Re: In the Matter of Avista Natural Gas
Integrated Resource Plan
OPUC Docket No. LC 81

Docket No. LC 81

Staff Final Comments
Second Errata

Figure 1: Comparison of Green Hydrogen Cost Trajectories

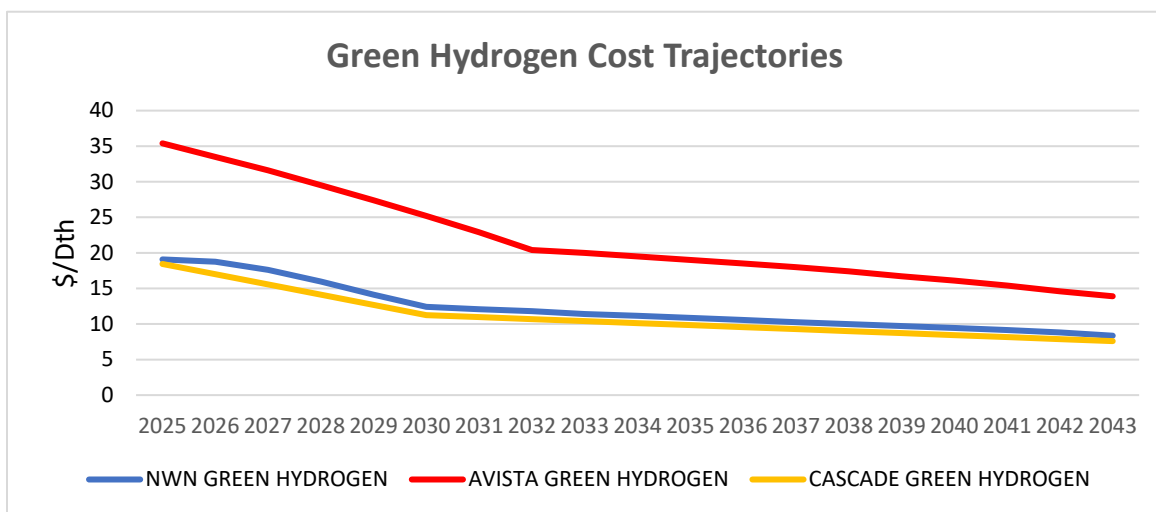
Staff agrees with CUB’s assessment of the risks associated with synthetic methane, however, differs slightly regarding CUB’s assertion that Avista needs to rely on an “established method.” Staff supports Avista’s efforts to project new supply side resource costs and availability and encourages Avista to explore and critique objective third-party sources that could be used to project costs and availability as part of the TAC process for developing future IRPs. While Avista’s estimates for green hydrogen costs as a feedstock to synthetic methane are conservative when compared against NW Natural and Cascade, as shown in Figure 1,⁷ Staff remains concerned about the Company’s ability to produce or procure the green hydrogen required to produce synthetic methane at the scale projected by Avista in its IRP.

*Figure 2:
Comparison of
Dairy RNG IRP
Estimate and RFP
Bids*

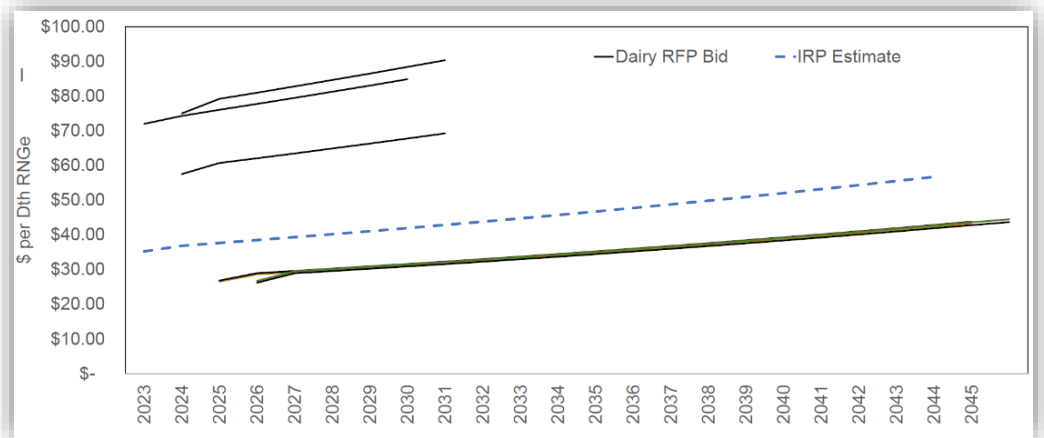
Avista addresses Staff’s request regarding how cost assumptions have changed since the 2018 Black & Veatch report by providing four charts comparing RNG pricing of the “IRP Estimate” derived from the report versus RFP bids Avista received.²² Of the four charts, only Avista’s solid waste IRP estimate is perceivably higher than then RFP bids. Avista’s IRP estimate for landfill and wastewater RNG is much lower than at least a majority, if not all the RFP bids. Dairy is likely closer to the middle of pricing based on the RFP bids, but without detailed workpapers, also appears perceivably lower than average. Avista states that the RFP prices consider market factors including Low Carbon Fuel Standard (LCFS) and Renewable Identification Number (RIN) program in the bid price.

Staff agrees with CUB that the RNG pricing is unreasonably low and that this undermines the Oregon PRS and IRP long-term plan generally.²³ While RNG is not the Company’s primary CPP compliance resource, it remains a consistently large resource in the PRS, starting in the near-term and maintaining importance throughout. If the resource is being underpriced, this could have negative impacts particularly on utilization of CCI and DSM programs, each of which represent smaller portions of the resource mix. The RNG cost comparison charts provided by Avista reinforces this concern. IRP RNG pricing that does not include important market factors, including LCFS and RIN program pricing, are unreasonably low and do not accurately represent the cost of RNG, therefore, lead to RNG to potentially overcrowding the Company’s Oregon PRS

Figure 6: NW Natural meter counts showing the return of a 2011-2015 trend of where meters decline in Q2-Q3 before rebounding in Q4 and Q1. The trailing 12-month growth rate is also at an all-time low since 2012.

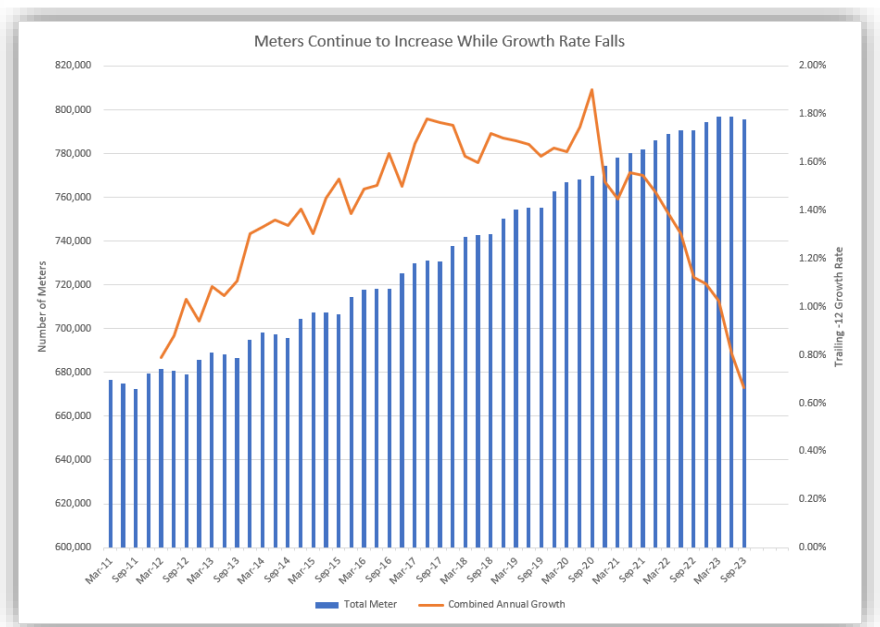
To start to understand baseline electrification occurring naturally, Staff recommends Avista use advanced metering infrastructure data and Form 10Q data to capture customer behavior. By the next IRP, Avista should present that information in the worksheet template included as Attachment B. An example of captured customer behavior from NW Natural’s Form 10Q is shown in Figure 6. This graph shows that even as meters increase, growth rate falls, suggesting increased energy efficiency measures and the natural electrification of end-uses. Such data can then be used

as inputs in econometric modeling of electrification by use or by locality. Captured changes in behavior and energy use suggest that LDCs, in consultation with electric utilities, municipalities,

Figure 7: Forecast Space Heat Costs

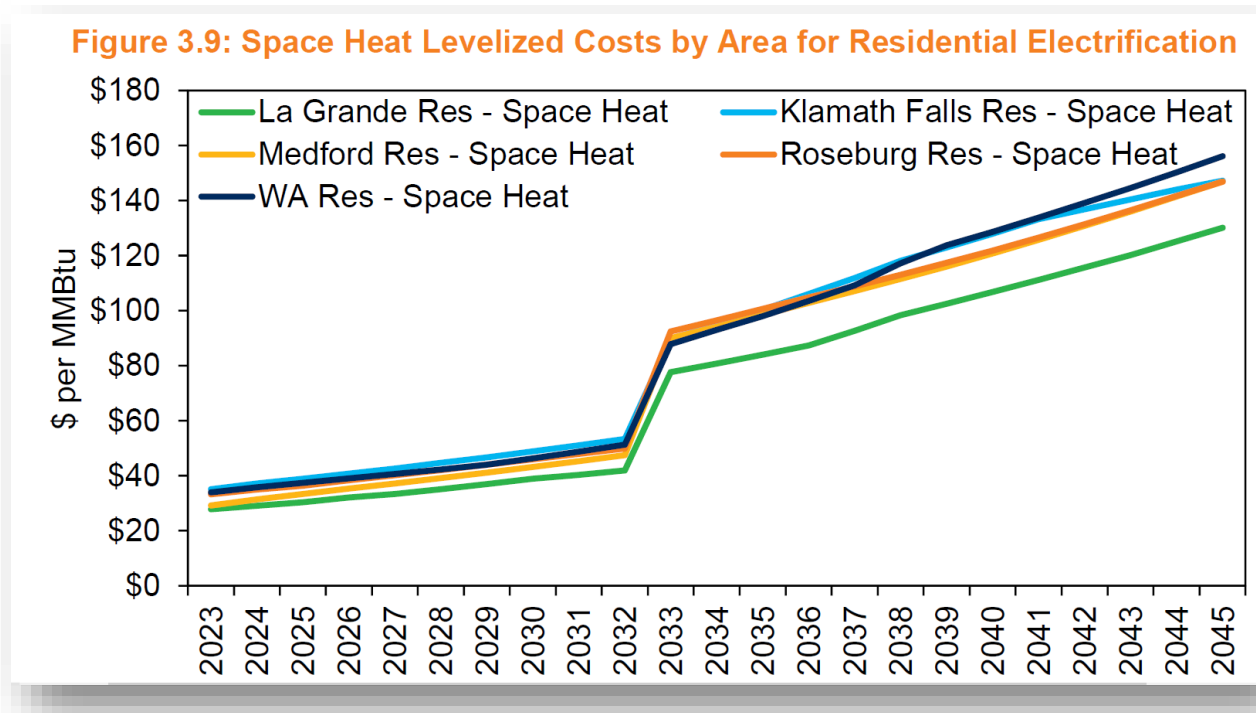
Figure 7 below shows Avista’s forecasted cost for electric space heat inclusive of a 50 percent reduction in conversion costs for IRA incentives and increasing electric rates.¹⁴³
